May 20, 2014

DOMINION VIRGINIA POWER
NORTH ANNA UNIT 3 COMBINED LICENSE APPLICATION
MARKUPS TO FSAR SECTIONS 3.7 AND 3.8 AND COLA PART 10

Markups to FSAR Sections 3.7 and 3.8 and COLA Part 10

Figure 3.7.2-201 SASSI2010 Plate Elements for RB/FB Basemat

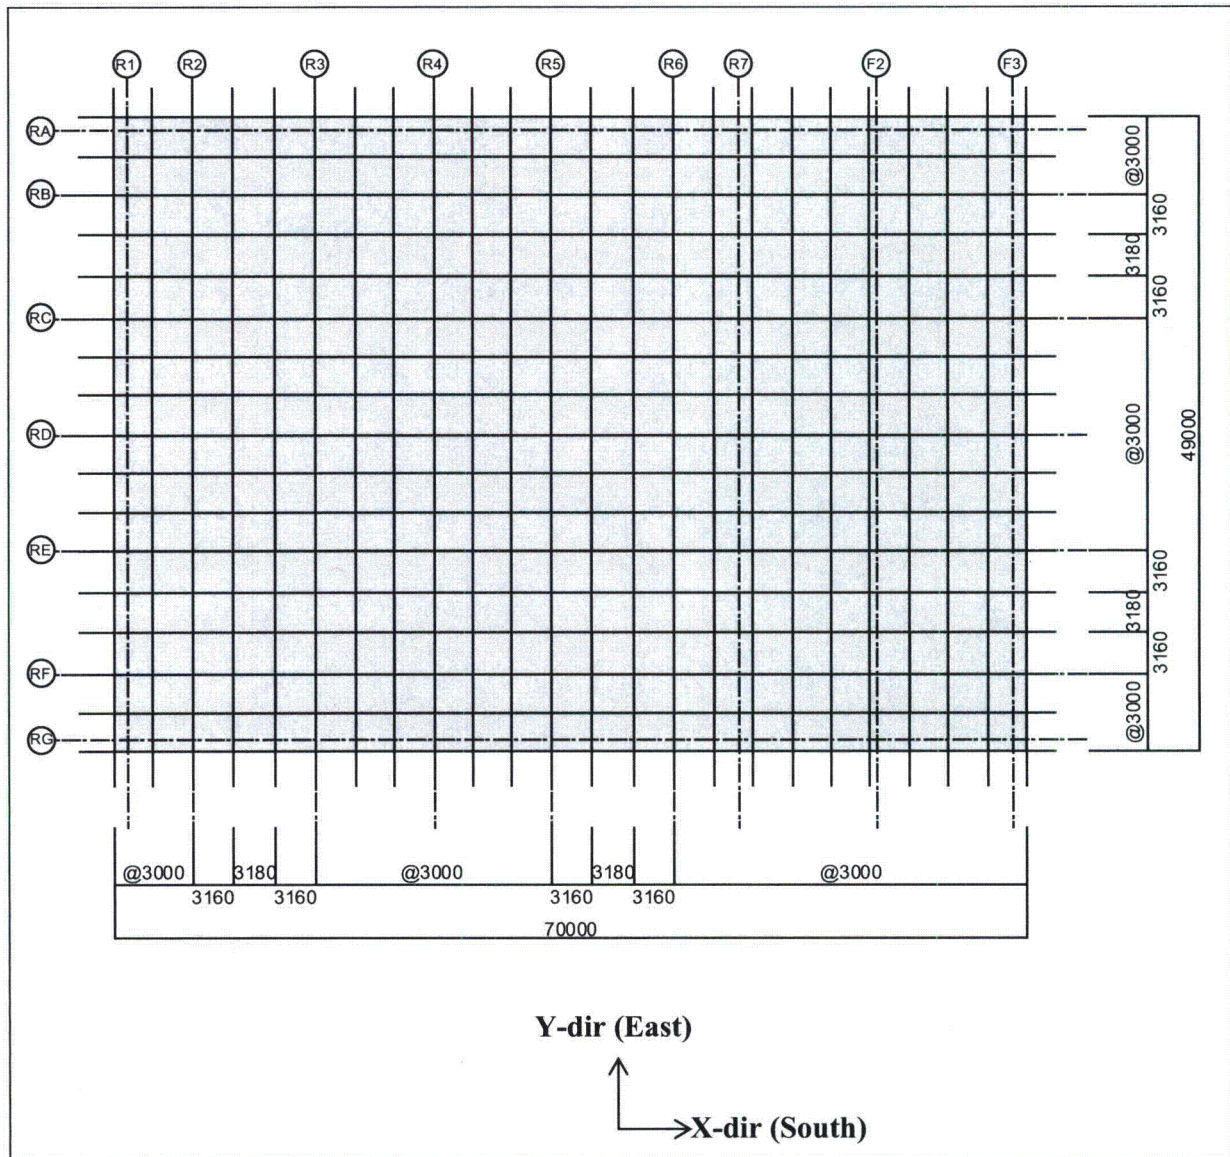
Table 3.7.2-224	Changed title from "Ratio with DCD Enveloping Max. Vertical Acceleration..." to "Ratios of Enveloping Maximum Vertical Accelerations...". Changed subheading (a) from "Site-Specific Envelop..." to "Site-Specific Enveloping...". Changed subheading (b) from "...DCD Loads" to "...DCD Acceleration."	Editorial
Figure 3.7.2-201	Added x-y orientation to RB/FB Basemat plan view	Editorial
Figure 3.7.2-202	Changed "FG" to "RG" in item (a) caption	Error in layout presented
Figure 3.7.2-203	Added modeling notes for RB/FB SASSI 2010 Model	Editorial
Figures 3.7.2-203 & 3.7.2-204	Added x-y orientation to CB Basemat plan view	Editorial
Figure 3.7.2-205	Added 'SASSI2010' to title	Editorial

Figure 3.7.2-207 SASSI2010 Plate Elements for FWSC Basemat

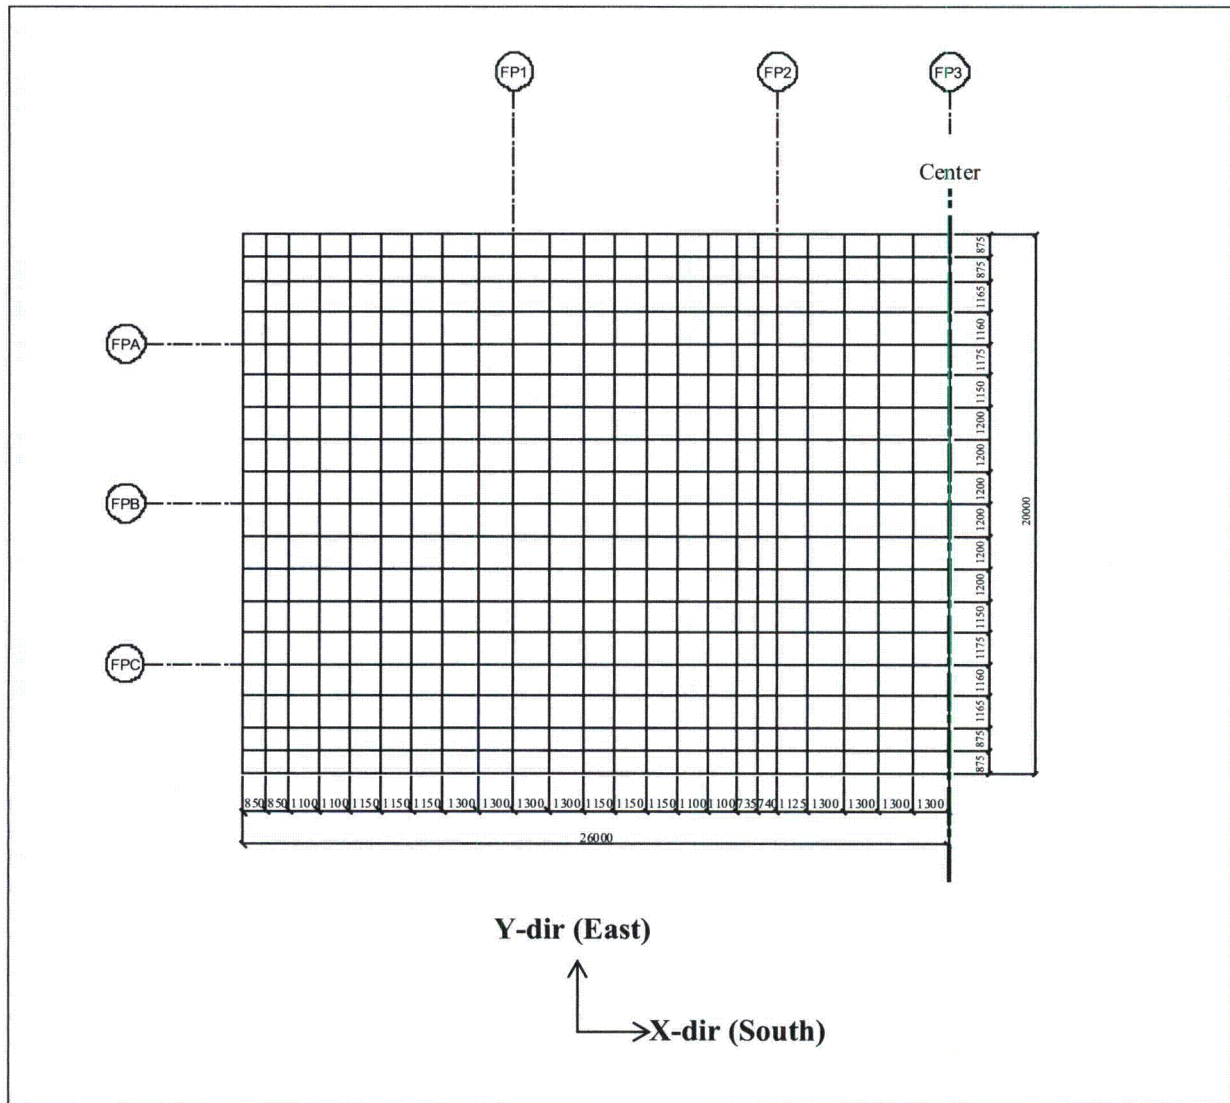
Section	Changes	Reason for Change
Figure 3.7.2-206	Added modeling notes for CB SASSI 2010 Model	Editorial
Figure 3.7.2-207	Added x-y orientation and column lines to FWSC Basemat plan view	Editorial
Figure 3.7.2-209	Added modeling notes for FWSC SASSI 2010 Model	Editorial
Figure 3.7.2-210	Corrected RB/FB Figure associated with cracked elements	Error in figure
Figures 3.7.2-211 thru 3.7.2-282	Corrected figure content to correspond with updated analysis	Updated analysis

Figure 3.7.2-210 RB/FB Complex Seismic Model with Cracked Elements

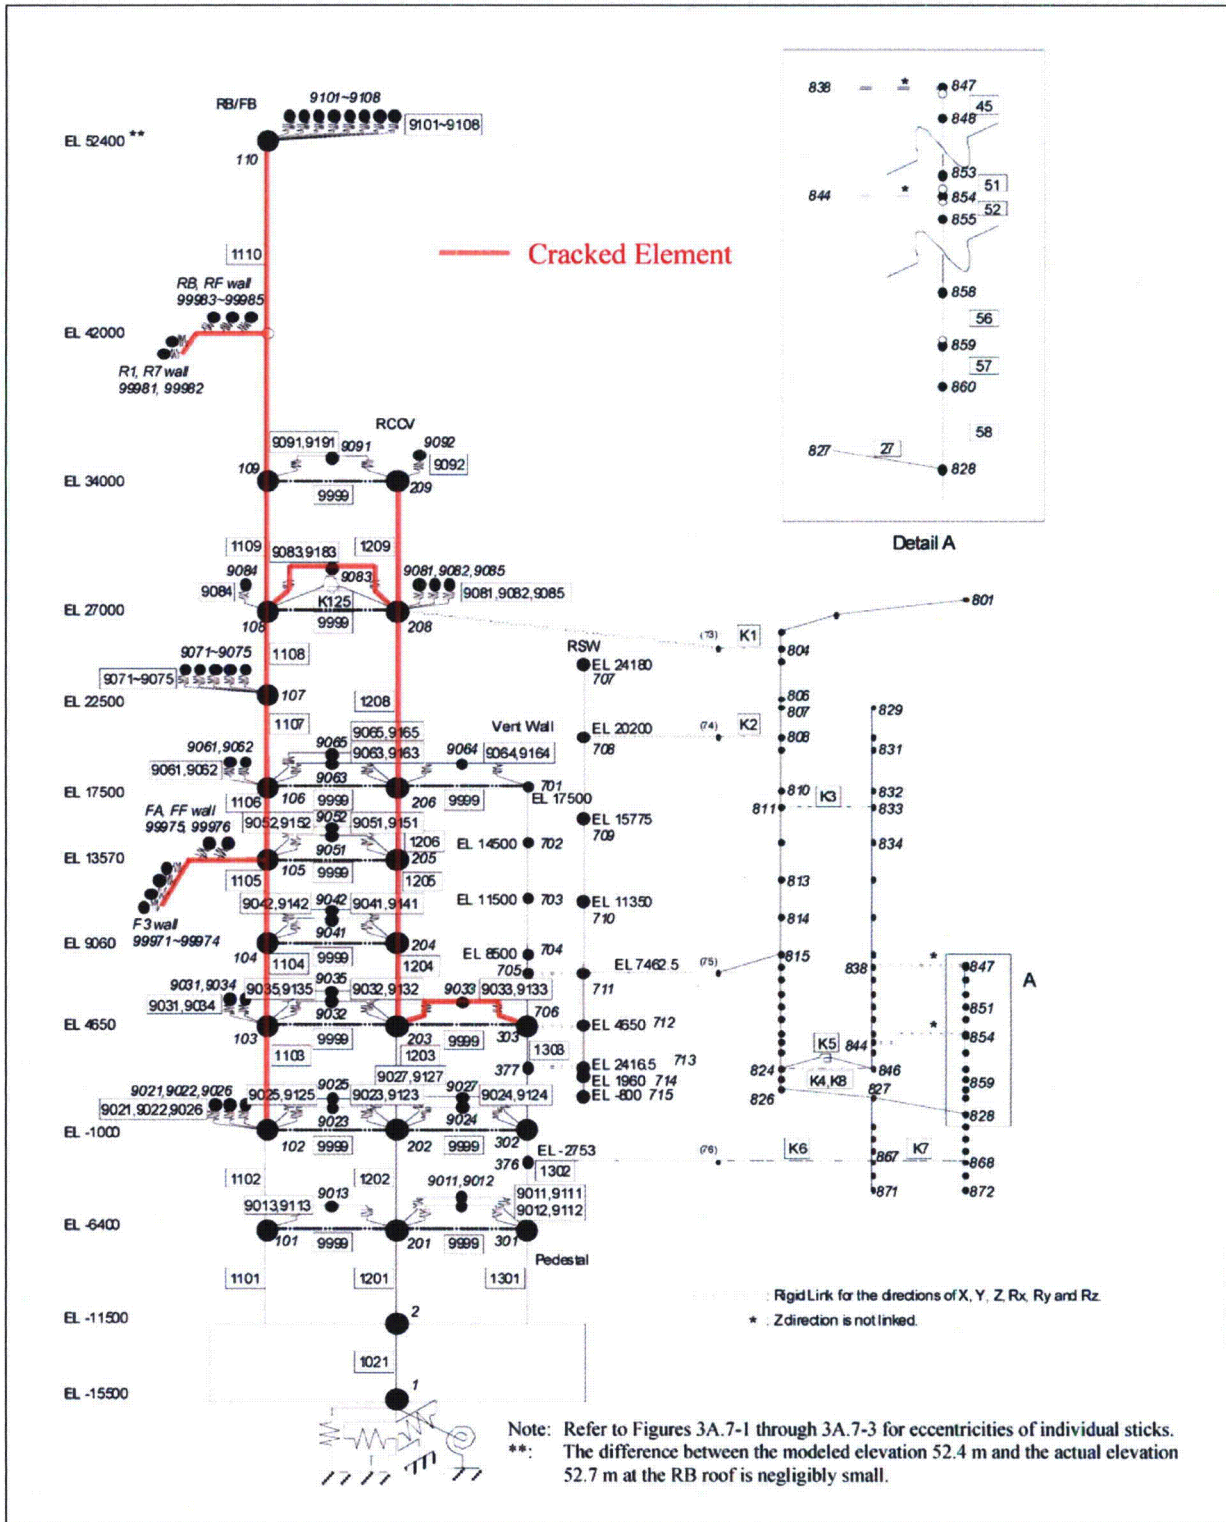
Figure 3.7.2-210 shows in red the elements of the RB/FB lumped mass stick model that are assigned with reduced cracked concrete stiffness properties and SSE damping. The RB/FB SDOF oscillators that are shown in red are also assigned with reduced cracked concrete stiffness properties and SSE damping. Reduced cracked concrete stiffness properties and SSE damping are assigned to all stick elements of the CB lumped mass stick. The FWSC model is assigned full (uncracked concrete) stiffness properties and OBE damping.

Figure 3.8.4-203 Lateral Soil Pressure - RB/FB RA/RG/~~FG~~FF Wall

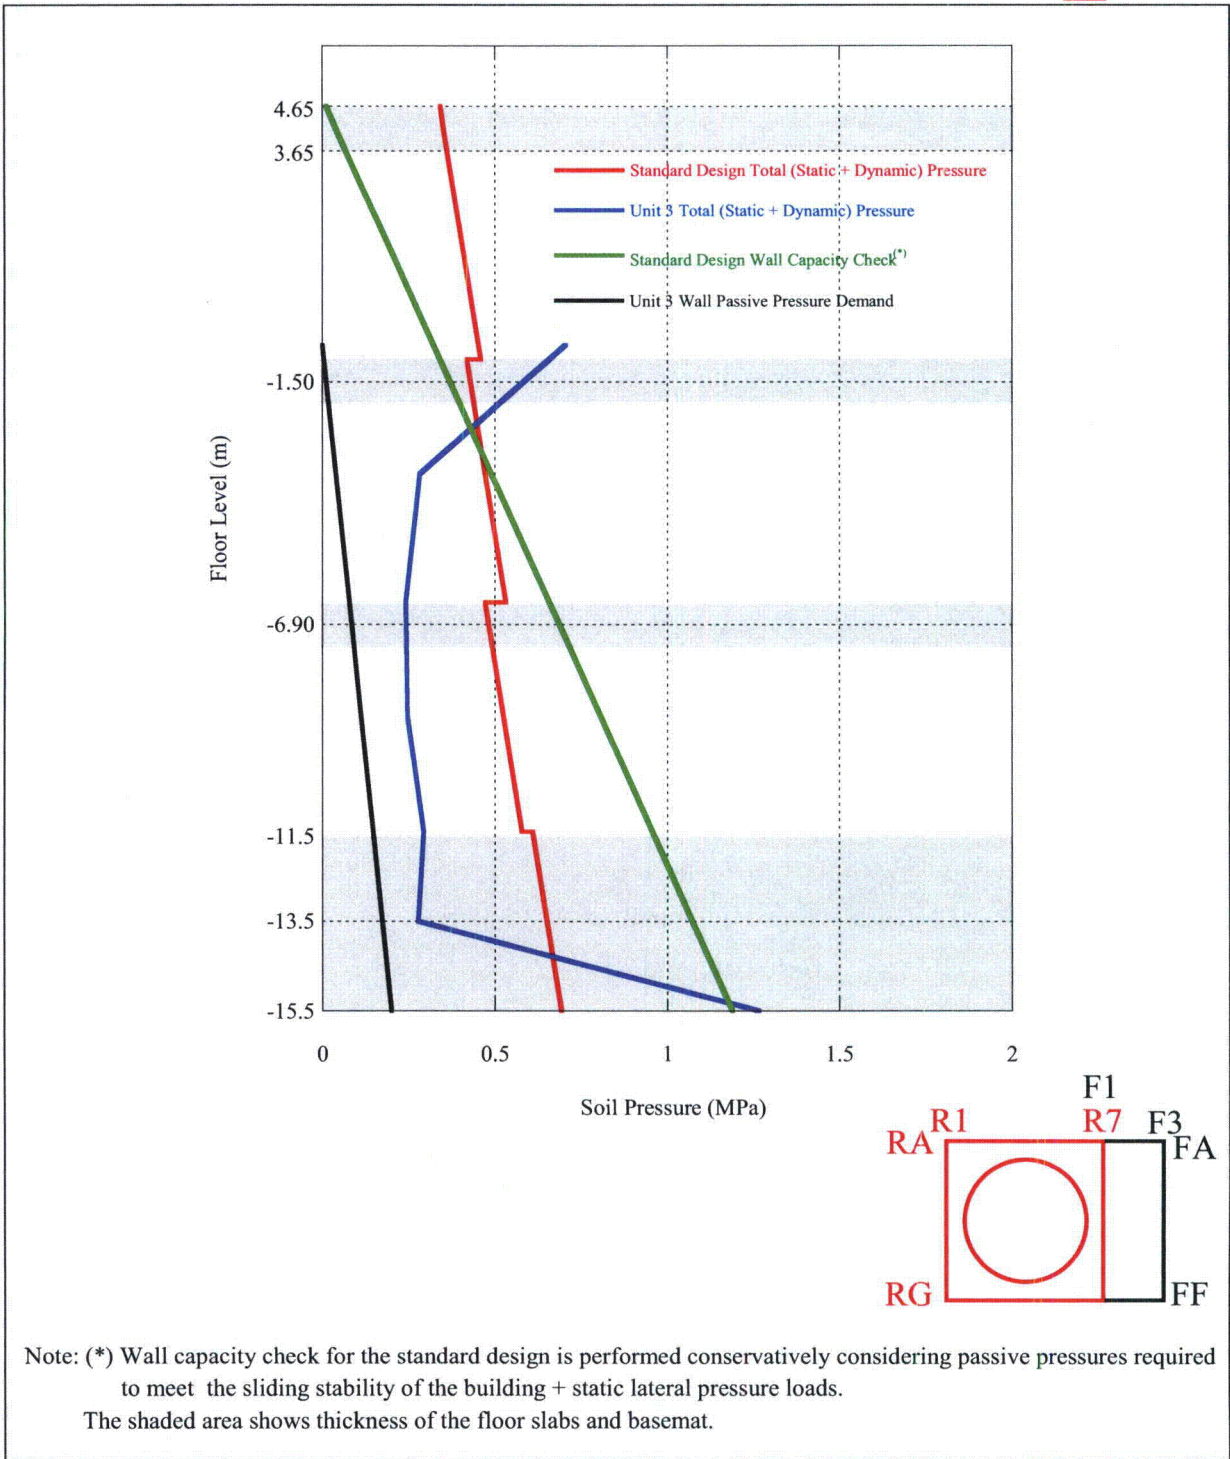
[Figures 3.8.4-201](#) through [3.8.4-204](#) show the Unit 3 site-specific lateral soil pressure demands on each of the four exterior walls of the RB/FB. The distributions of the site-specific total lateral pressures that include the site-specific hydrostatic pressure, the static lateral pressure and the dynamic lateral pressure obtained from Unit 3 site-specific SSI analyses

As shown in [Figures 3.8.4-201](#) through [3.8.4-204](#), the Unit 3 lateral pressure demands on the walls of the RB/FB are bounded by the ~~Referenced~~ DCD design soil pressures and DCD wall capacity passive pressures except at the top of the Zone III rock. These sharp exceedances of the site-specific lateral pressures are due to SASSI calculations of the site-specific seismic lateral pressures at the top of the concrete fill model. Their effects on the out-of-plane bending moments and shear forces in the walls are small and are bounded by the standard design.

Figure 3.8.4-204 Lateral Soil Pressure - RB/FB FA Wall

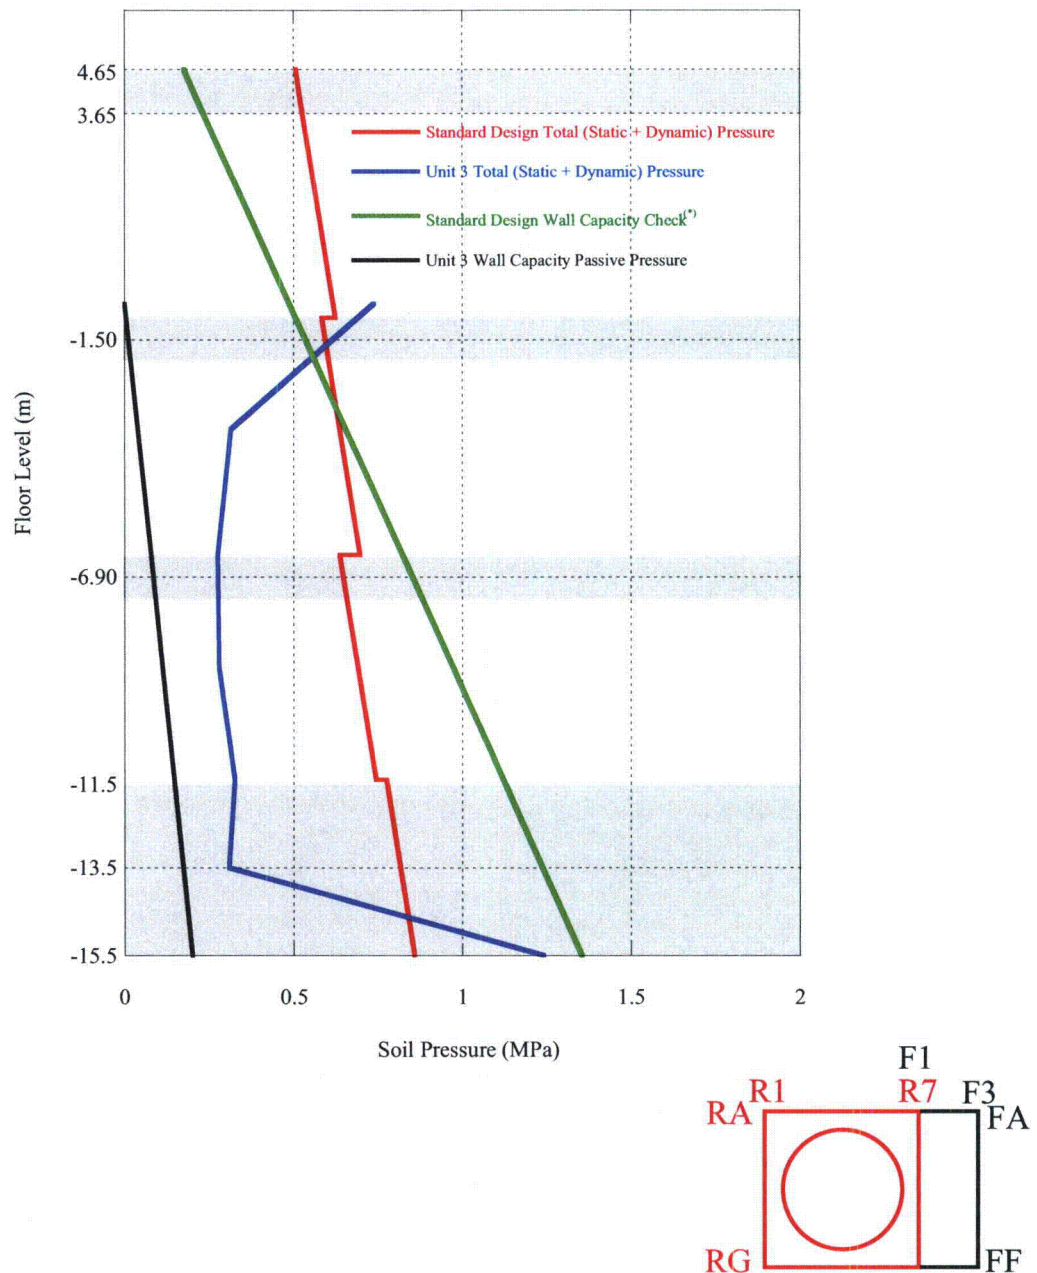
3.8.5.5.2	Added clarifying detail	Editorial
Table 3.8.5-201	Revised units for lateral pressure	Editorial
Table 3.8.5-202	Revised units for lateral pressure	Editorial
Table 3.8.5-203	Revised units for lateral pressure	Editorial
Tables 3.8.5-204 thru 3.8.5-206	Revised calculated values due to updated analysis (revised values are marked as inserts)	Updated analysis
Figures 3.8.4-201 & 3.8.4-202	Revised figure title to correct column lines	Updated analysis
Figure 3.8.4-203	Deleted extra floor level elevations axis values for building lateral soil pressure. Changed "FG" to "FF" in title.	Editorial Error in column designations Updated analysis
Figure 3.8.4-204	Revised to correct CB column line designation	Updated analysis
